DELEGATED POWERS DECISION

Stoke Newington Church Street / Clissold Road Improved access to Clissold Park Proposed parallel walking and cycling crossing

Figure 1: Stoke Newington Church Street - Existing zebra crossing outside Clissold Park

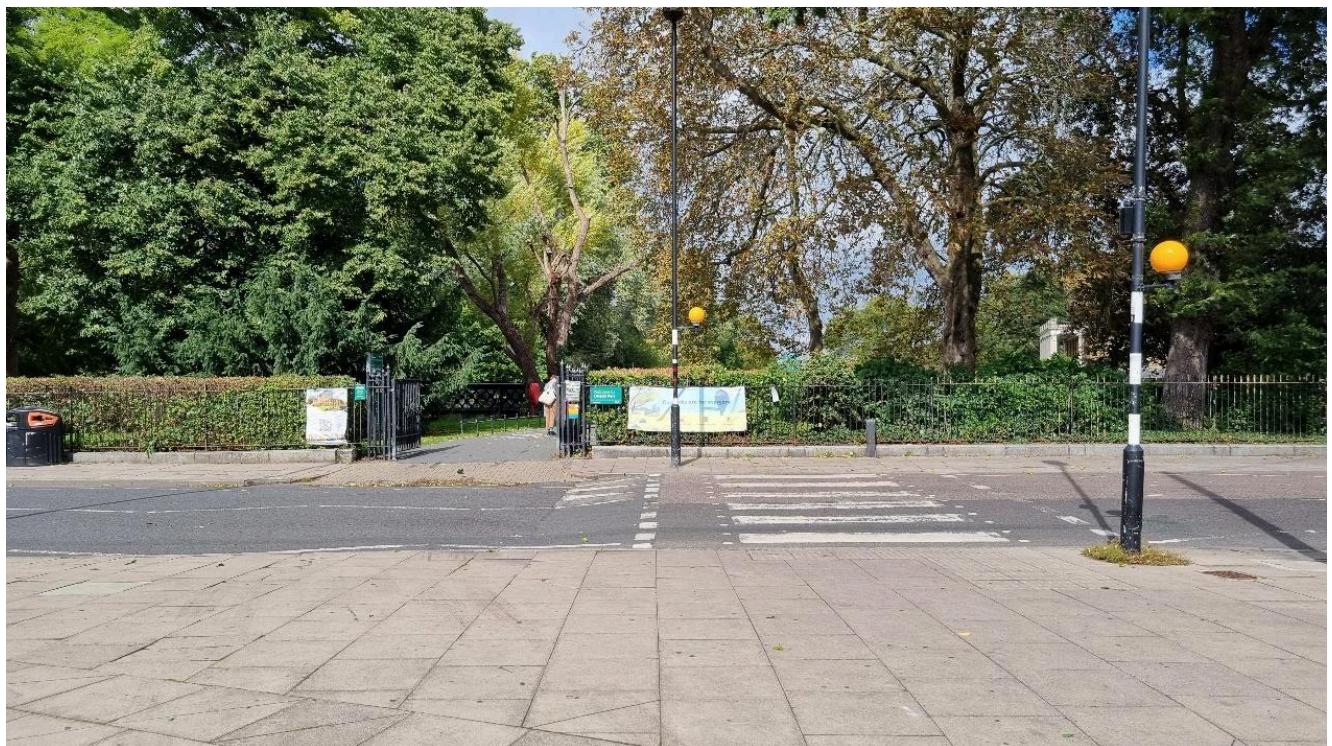
- 1.4 For cyclists, this junction sits on an important alignment connecting Islington, Finsbury Park and Green Lanes to Hackney and Cycleway 1 towards Central London. However, the current layout does not provide a safe or formalised crossing for cyclists, who often use the existing pedestrian zebra crossing, leading to potential conflict and discomfort

for both cyclists and pedestrians. The only legal alternatives currently available involve cyclists carrying out dangerous right-turn manoeuvres against oncoming traffic, either into Clissold Road or directly into the park from Stoke Newington Church Street. At the same time, Clissold Park is heavily used by less experienced cyclists, children and families for leisure and cycle training, making it especially important to provide a safe and predictable way for them to enter and exit. The proposed formalised crossing will reduce risks at this busy junction, improve comfort for pedestrians and ensure that young and less experienced cyclists have a safer, more controlled route to and from the park.

- 1.5 The proposed parallel crossing will provide a clear and safe route for cyclists while maintaining pedestrian priority. It aims to support Hackney's wider goals for active travel and inclusive street design.
- 1.6 Encouraging the use of cleaner transport options and reducing non-essential private car journeys are key long-term objectives for the Council due to the wide range of benefits these transport options can bring, including:
 - Reducing potential road accidents
 - Creating safer, cleaner and quieter streets
 - Improving personal mobility and health through the use of sustainable transport.

Appendix 1 - Stoke Newington Church Street / Clissold Road Improved access to Clissold Park - Proposed parallel walking and cycling crossing

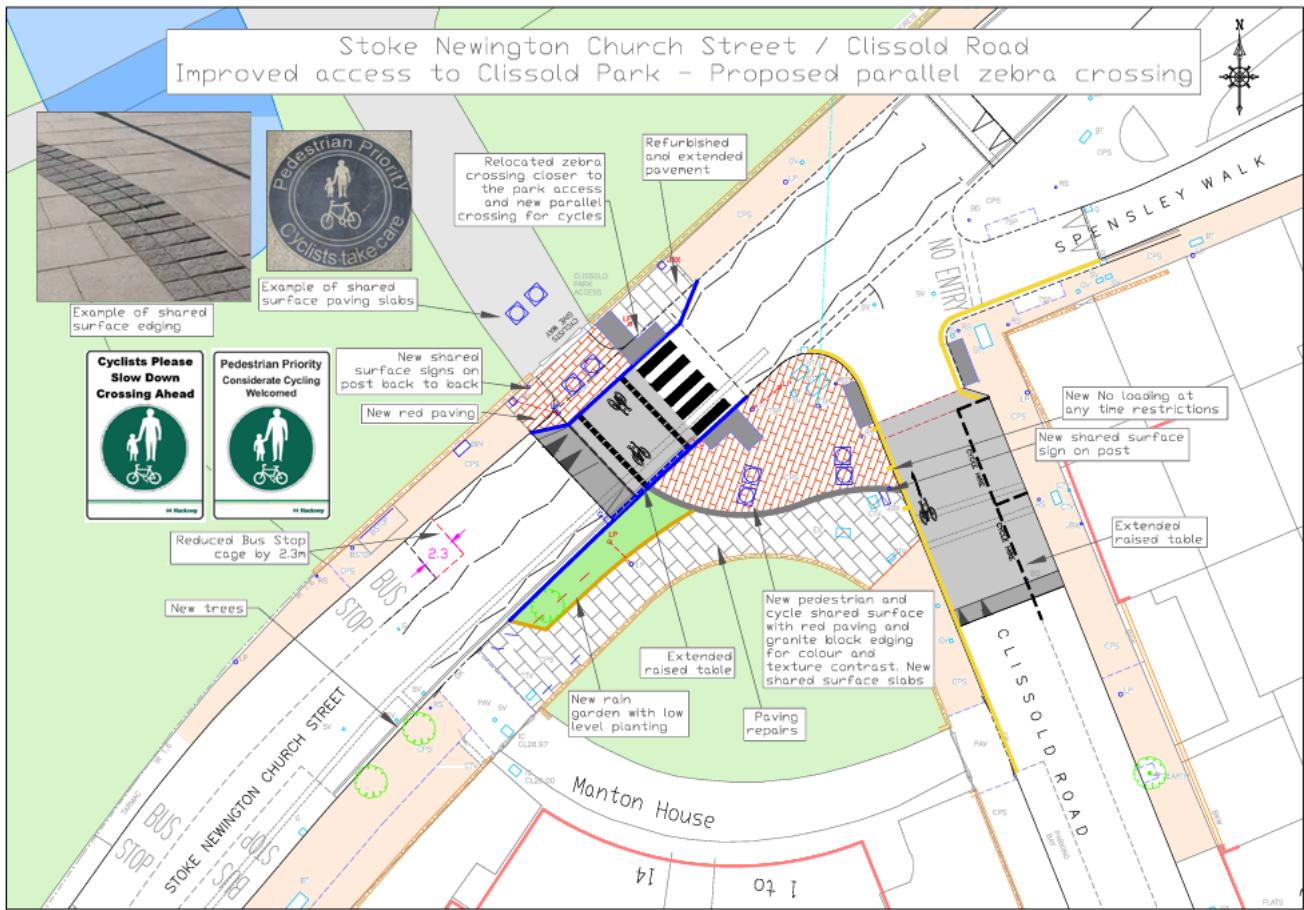
3.4 We welcome upgrading the zebra to a parallel crossing. Cycle speeds should be low here, having exited or entering the park, so we envisage that the shared space will work as it does currently in the park. If the approach with the cycle track across the pavement is progressed, we welcome the use of a different colour paving to help differentiate. If there is to be a cycle track across the pavement, it should have tactiles and 60mm high demarcation kerbs for the benefit of visually impaired people. Without the kerb, a full shared space may be preferable. We like to see rain gardens, but it may impact the pedestrian desire line.”

3.7 We do not like the cycle path crossing diagonally over the pavement in that overly defined way, as it reinforces cycle priority over pedestrians crossing. Some of our members are against running the cycle way over the footway at all. We would prefer pedestrian priority for those walking along the footway south alongside Church Street, and west footway alongside Clissold Road without having to give way to cyclists crossing diagonally over the footway. It should be cyclists giving way to pedestrians as they cross the footway. As it is clear here that there is no way for cyclists to cross over into the Park without crossing the footway, and they should not have to get off and walk, perhaps they could slow down as it is not a long stretch here, making it a shared space with use of both cycle symbols but with pedestrian priority signs. It would be preferable to have no kerbs and no heavy textured paving to the edge of the defined cycle route across the footway as these would be a trip hazard on a direct pedestrian route and also encourage cyclists to go faster as a clearly delineated and prioritised route for them has been created. We would prefer the textured paving (with no level difference) to be at the perimeter of the entire shared area, and for the entire shared section to be a different contrasting colour, so that both sets of users have maximum warning of the sharing and that there is pedestrian priority in this section. Obviously, the threat from cyclists is minuscule compared to that from vehicles but as bikes increase in size and with some electric bikes being enormous and quite fast, it becomes more important to consider and prioritise pedestrian safety and recognise that there is a some level of risk to pedestrians from cyclists. There are a minority but considerable number of cyclists who are incredibly reluctant to stop even when pedestrians have priority. I don't necessarily see the problem with cyclists having to stop every now and then. All other road users need to at some point and I say this as someone who walks and cycles and uses this particular crossing regularly.

3.9 We are concerned about the current proposal for two main reasons: it doesn't seem to be prioritising pedestrians (who are top of our hierarchy in parks); and it is likely to lead to increased speed of cyclists entering the park. The gate is half locked down, it will come to a pinch point with users especially in the summer and it is our main gate for deliveries.

3.15 I have reviewed the attached plans, and the MPS do not object to the scheme, but I have a couple of questions/observations: I visited the location last week for about 30 minutes in the mid-morning. The entrance to the park does appear to be in almost constant use by both pedestrians and cyclists (and some motor vehicles involved in park maintenance etc). Many of the cyclists – particularly those travelling south on Stoke Newington Church Street turn into the park using some/all of the zebra crossing. I understand the desire to formalise this usage as a Parallel Crossing. I am aware Hackney has committed to the use of grey tactile paving (instead of red at controlled crossings as per standard guidance), and usually highlight this deviation from standard. However, the current tactile paving is worn/weathered so no longer provides any contrast to the surrounding footway. The proposed scheme will provide better colour contrast between paved areas and tactile paving. I note the intention to extend the raised tables. Will the carriageway here be raised to footway level? If so, it appears that there will be no detectable feature to prevent/assist visually impaired pedestrians from inadvertently entering the carriageway (such as if they had walked north on Clissold Road – potentially missing the tactile paving). Has a speed survey been carried out on Stoke Newington Church Street. I believe it is subject to a 20mph speed limit – is data available to suggest traffic is adhering to that limit? I have some concerns regarding intervisibility between drivers approaching the crossing, and cyclists approaching from the park. Slower speeds will allow more time to see and be seen. As above, I have concerns that some cyclists may approach the crossing too quickly to properly assess whether it is safe to cross – there is almost no vision to the right for cyclists travelling south through the park – and this will only be further diminished when a bus is servicing the bus stop. The bus timetable at the stop suggests buses stop around every 10-12 minutes for route 393 only. I acknowledge that the kerb build-out and reduction in the length of the bus-stop will increase the visibility.

3.19 The CPUG shared the following comments (summarised here; their full submission, which contains substantial and material information, is provided in Appendix 2): concerns that the proposed layout undermines pedestrian priority, as the cycle route leads directly into the park and may encourage cyclists to enter without slowing down; safety concerns at the park entrance, particularly given existing congestion near the bridge and the volume and speed of cyclists, including e-bikes; concerns that the shared area on the south side (near the schools and leisure centre) will become overcrowded and increase risk for pedestrians at peak times. Feedback from the CPUG's own survey indicates strong public concern about cyclist behaviour and support for stronger calming measures. They also expressed disappointment that CPUG, park wardens and community police were not consulted as part of the pre-consultation stakeholder process. They requested further cyclist-calming measures at the park gates (e.g. chicanes) and suggested alternative solutions outside the park.

3.5 We note your comments regarding the southern side and agree that the proposed layout provides a defined route for cyclists. That said, we remain mindful of the need to ensure clarity for all users, particularly those with visual impairments. Your feedback on the paving is also agreed. We'll revisit the palette to ensure stronger colour contrast and explore options for clearer visual differentiation. Regarding the demarcation kerb for the cycle track, we understand the importance of the tactile provision and we'll assess how this can be incorporated within the spatial constraints and visual context. On the rain garden, we're reviewing its placement to ensure it doesn't obstruct key

3.8 We've carefully considered the points raised and have revised the design to better reflect shared priorities around pedestrian safety and cyclist behaviour. In response to concerns about the delineated cycle path across the footway, we've removed the defined diagonal cycle track to the south of Stoke Newington Church Street. Instead, we're proposing a shared surface treatment across this section, with the following features: Contrasting colour block paving (e.g. red or similar) to distinguish the shared area from the surrounding concrete slabs. Same-level texture contrast along the perimeter of the shared zone, to subtly show the transition without introducing trip hazards. Cycle symbols and pedestrian priority signage to reinforce the shared nature of the space and encourage slower cycling speeds. We believe this approach

3.10 The design has been amended to remove the defined cycle track and replace it with a shared surface, supported by contrasting paving and pedestrian-priority signage. A new kerb build-out and extended raised table will improve visibility and reduce vehicle speeds, while signage at the park gates will encourage cyclists to slow down on entry and exit. The scheme is intended to formalise existing cyclist movements and reduce conflict, particularly for families and less experienced riders, while maintaining pedestrian priority. Regarding the concerns about the gates being half-closed, our view remains that this serves as a physical feature to encourage cyclists to slow down, consistent with how the access point currently functions. We are however continuing discussions with the Parks team, to look at ways to further improve the situation and explore additional measures at the gate, such as a collapsible bollard or similar intervention where appropriate. We do not anticipate a significant increase in cyclist volumes specifically due to the new parallel crossing. However, the new design will better separate pedestrians and cyclists, reducing the existing conflict that occurs when both groups share the zebra crossing.

- 1. Parallel crossing justification: we agree with your assessment of current cyclist behaviour at the park entrance. The proposed parallel crossing is intended to formalise this movement and reduce conflict between pedestrians and cyclists, particularly at peak times. The design aims to reinforce pedestrian priority while providing a safer, clearer route for cyclists entering and exiting the park.

- 2. tactile paving and colour contrast: the new scheme will include tactile paving with improved colour and texture contrast, supporting visually impaired users. While Hackney continues to use grey tactile paving in line with borough-wide policy, the new materials will be selected to ensure better visual distinction than the current worn surface. We are also proposing to use red paving which will contrast clearer with the grey tactile paving.

- 3. Raised table and detectable features: the carriageway will be raised to footway level at the crossing. We acknowledge your concern regarding the potential lack of detectable features for visually impaired pedestrians. To address this, we are reviewing the inclusion of additional delineation strips at key transition points, particularly for those approaching from Clissold Road. This was not raised by the Road Safety Audit.

- 4. Speed survey and intervisibility: a speed survey was carried out in July 2024. Initial findings suggest general compliance, but we are reviewing whether additional traffic-calming measures or SLOW road markings may be appropriate to further reduce speeds and improve intervisibility at the crossing. Summary of the traffic data collected: between 1 July 2024 and 7 July 2024, a two-way traffic survey recorded a five-day average flow of 5,184 vehicles and a seven-day average of 5,193 vehicles, with an 85th percentile speed of 21.9 mph and an average speed of 17.0 mph.

- 5. Cyclist approach and bus stop visibility: we share your concern regarding visibility for cyclists approaching from the park, particularly when a bus is present and this was also raised by the Road Safety Audit. The proposed kerb build-out and reduction of the bus cage length were added to the design to mitigate this issue. We are also exploring options for additional signage and surface treatments (like give way lines) within the park, to encourage cyclists to slow down and assess the crossing safely.

3.20 The concerns raised by CPUG are acknowledged, including the potential for increased pedestrian–cyclist conflict at peak times and the risk that some cyclists may enter the park at inappropriate speeds. These issues have been considered in the development of the final design and opportunities for additional calming features within the park will continue to be explored in collaboration with Parks and other stakeholders. Although

the layout may appear to prioritise cyclists, which could be seen as contrary to the Highway Code's hierarchy placing pedestrians first, in response to feedback, the zebra crossing has been relocated closer to the park gates to strengthen pedestrian priority where it is most needed.

2. Safety at the park entrance:

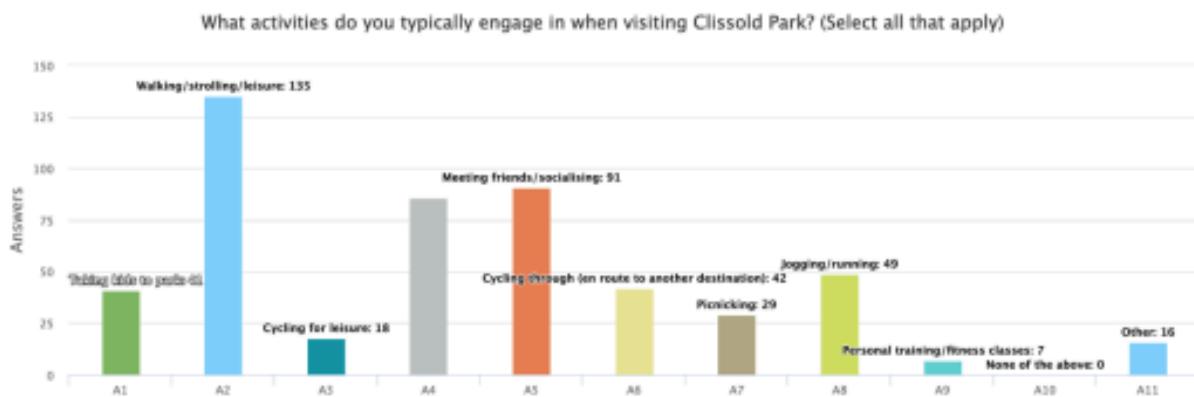
Once inside, cyclists gain faster, more direct access to an already congested area near the bridge, a known pinch point.
